# SERVICE BULLETIN

<b>SERVICE BULLETIN</b>		NO. : MSB-97E11-502	
		DATE : 1997-02-28	<MODEL> ECLIPSE(D30) CARISMA
SUBJECT : CHANGE IN LASH ADJUSTER CHECKING PROCEDURE		<M/Y> 96-10 96-10	
GROUP : ENGINE		DRAFTNO. : 96-AL-504	
CORRECTION	OVERSEAS SERVICE DEPT	 R. USAMI - MANAGER QUALITY INFORMATION ANALYSIS

The lash adjuster checking procedure has been changed as follows:

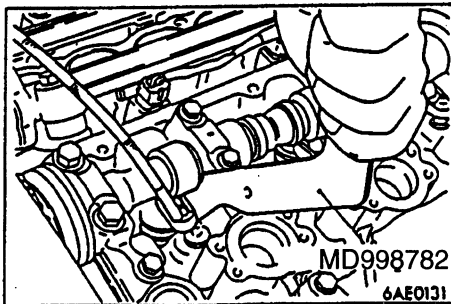
- 1) Perform simple lash adjuster check. (See page 5 of this Service Bulletin.)
    - If only one of the lash adjusters is found abnormal in the simple lash adjuster check (the rocker arm is pushed down easily), replace the lash adjuster.

- If two or more lash adjusters are found abnormal (the rocker arm is pushed down easily), clogged oil passage in the cylinder head is suspected. Check for clogged oil passage and repair the passage if it is clogged. If the passage is not clogged, replace the lash adjusters.

- If all the lash adjusters are found normal (the rocker arms are hard to push down) as a result of simple lash adjuster check, investigate other causes for the abnormal noise.

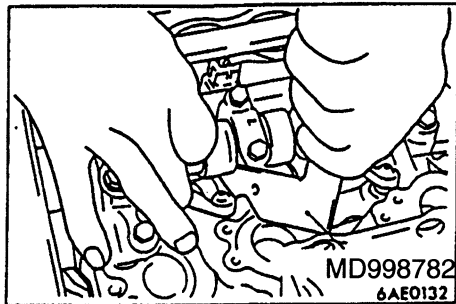
Before removing the lash adjuster, turn the crankshaft to lower the piston of the cylinder concerned. Otherwise, the valve will come into contact with the piston when the valve is lowered.

In addition, the lash adjuster cannot be removed at the rocker arm lifted by the cam.

In this case, turn the crankshaft so that the rocker arm may not be lifted by the cam.

- 1) Use the special tool to push down the valve and remove the roller rocker arm.
- 2) Pull out the lash adjuster from the cylinder head.
- 3) Install on the cylinder head the new lash adjuster from which air has been bled.
- 4) Use the special tool to push down the valve and install the roller rocker arm.

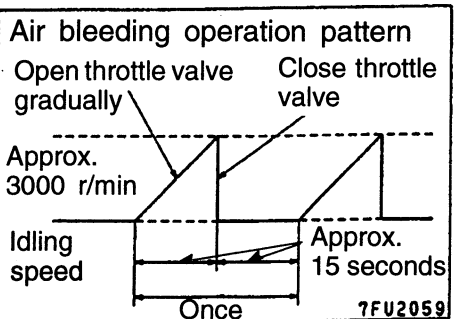
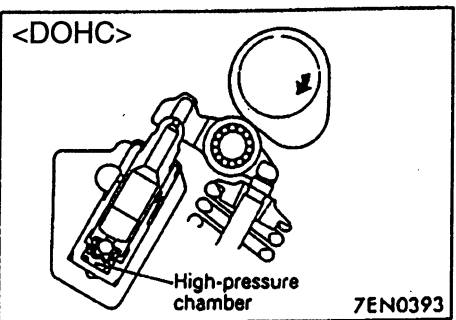
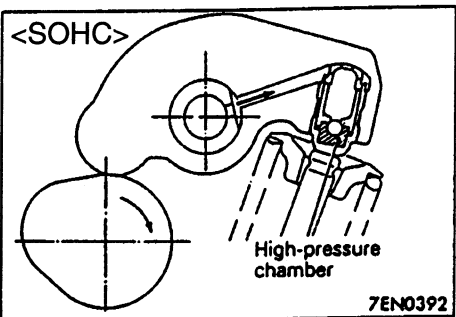
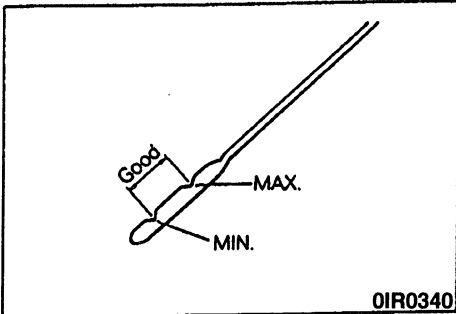
- (1) Stop the engine.
- (2) Remove the rocker cover.
- (3) Set the piston in No.1 cylinder at top dead center of the compression stroke.
- (4) Check the rocker arms indicated by a white arrow in the figure next page by the following procedure.

- 1) Check if a 0.1 – 0.2 mm leaf of the feeler gauge can be inserted between the valve and the lash adjuster.
  - 2) Record the corresponding lash adjuster as a defective if the leaf of the feeler gauge can be inserted easily.
  - 3) If the feeler gauge leaf cannot be inserted easily, the lash adjuster is in good condition. Therefore, investigate other cause of the abnormal noise.
- (5) Slowly turn the crankshaft 360° clockwise.
  - (6) Follow the same procedure as step (4) to check the rocker arms indicated by a black arrow in the figure next page.
